**Development Permit Panel
Electronic Meeting**

1. DEVELOPMENT PERMIT 18-829207
(REDMS No. 7570968)

PROPERTY LOCATION: 9520 Beckwith Road

That a Development Permit be issued at 9520 Beckwith Road to permit the construction of a 7 storey light industrial and office building on a site zoned "Light Industrial and Office (ZI19) – Bridgeport Village (City Centre)".

Drawing Title: PLANTING PLAN - LEVEL 5
 Drawing #: L-03B
 Project #: DP2018-29
 VZJ Project #

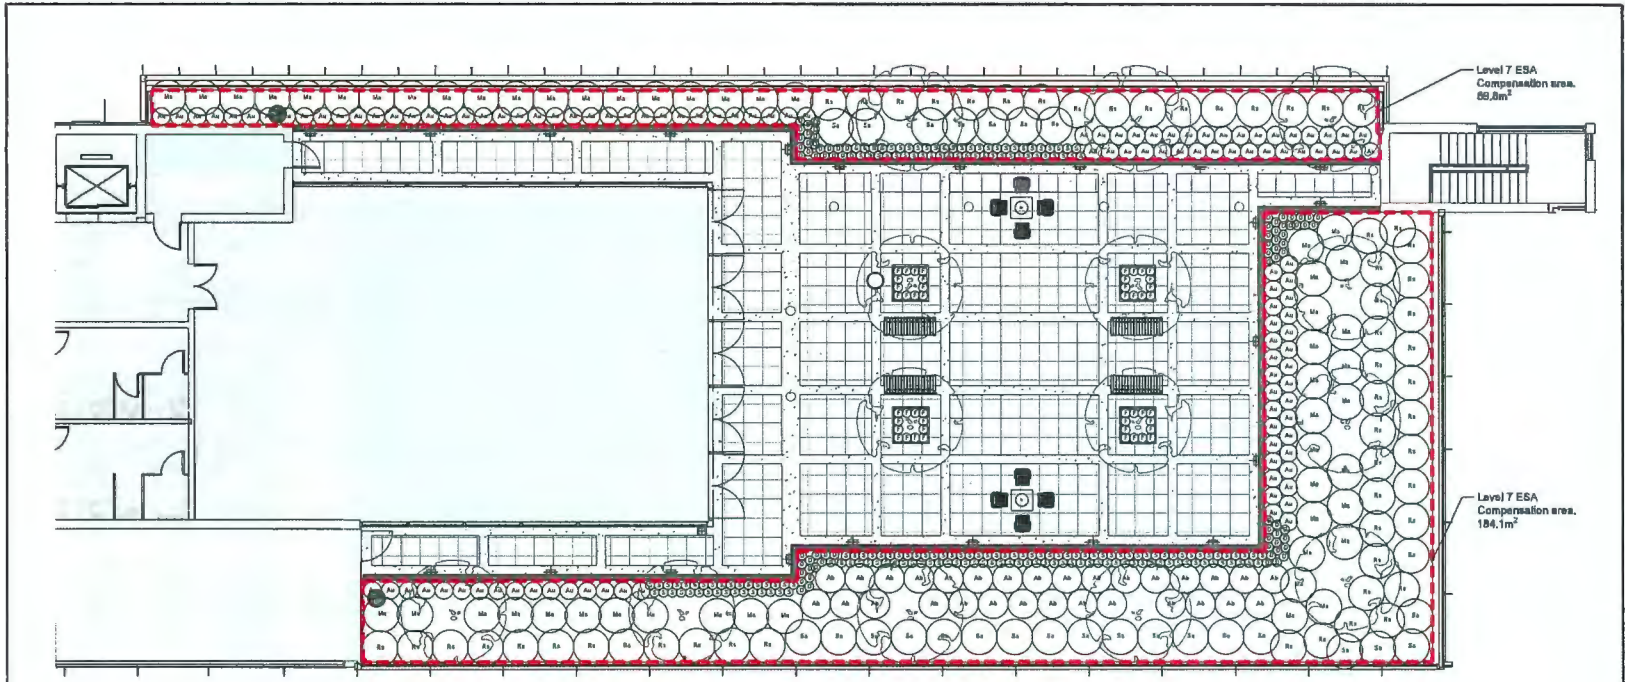
- appreciate the amount of planting in the project and extensive use of native species; concerned on vine planting below Level 5 which is not shown on the planting plan for Level 5 as it is technically not on Level 5; applicant needs to consider provision of maintenance access; ***IBI: Guardrail access will be provided to maintain step-down planter. A fixed ladder is shown on A1.05 (at Gridline L1 between Gridlines D/E).***

- support the Panel comment regarding the lack of provision for maintenance access for vines on the lower planter below Level 5; consider installing a permanent ladder structure on the outside to connect the higher Level 5 planter to the lower planter;
IBI: Guardrail access will be provided to maintain step-down planter. A fixed ladder is shown on A1.05 (at Gridline L1 between Gridlines D/E).

Drawing Title: **SITE PLAN - LEVEL 1**
 Drawing #: **L-02A**
 Project #: **DP2018-29**

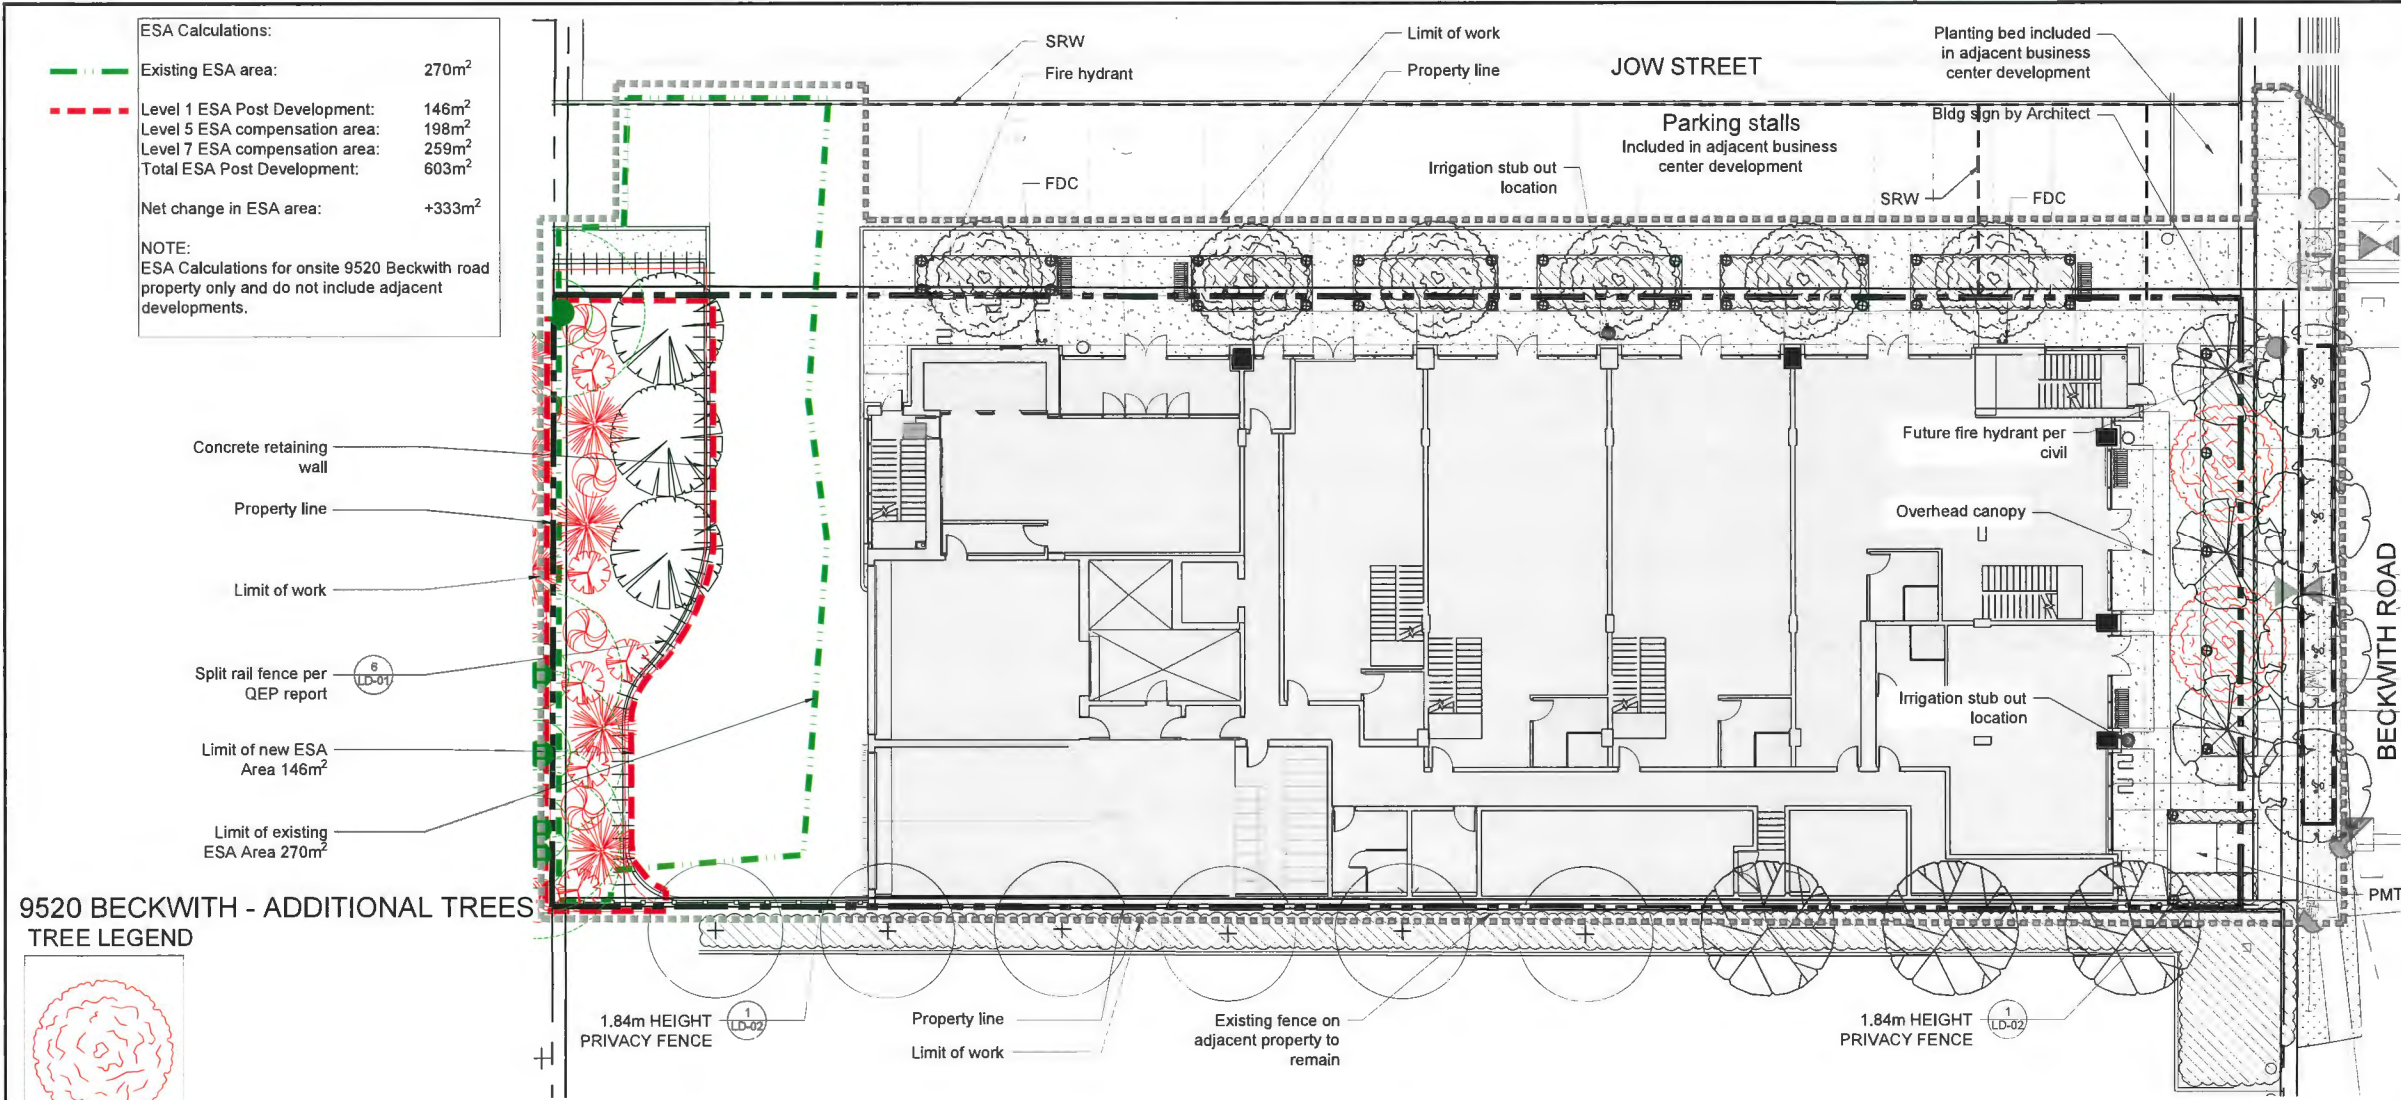
- appreciate the high density of tree planting and landscaping along the building's Beckwith Road frontage to provide a buffer to the existing single-family homes to the north; however, consider opening up the landscaped area along the north edge of the site to provide additional pedestrian access to the building from the north and address potential CPTED concerns; ***IBI: Landscaping at North elevation, along Beckwith road, was revised accordingly, to open up the elevation and introduce additional pedestrian connection. See A0.09 and L-02A***

- support the proposed bollard lighting along the west and north sides of the building;
- consider introducing landscaping around the Pad Mounted Transformer (PMT) fronting Beckwith Road to screen it from pedestrian view; ***IBI: Green hedge was added around PMT, to create aesthetic concealment. See A0.09 and L-02A.***

- shadow study shows that the north elevation is a dark space most of the time; high density of planting including trees, native shrubs and planters along the Beckwith Road frontage will pose sightline issues; consider keeping the planting low and open up some of the trees to allow more sunlight; ***IBI: Landscaping at North elevation was revised accordingly, to allow more sunlight in. See A0.09 and L-02A***
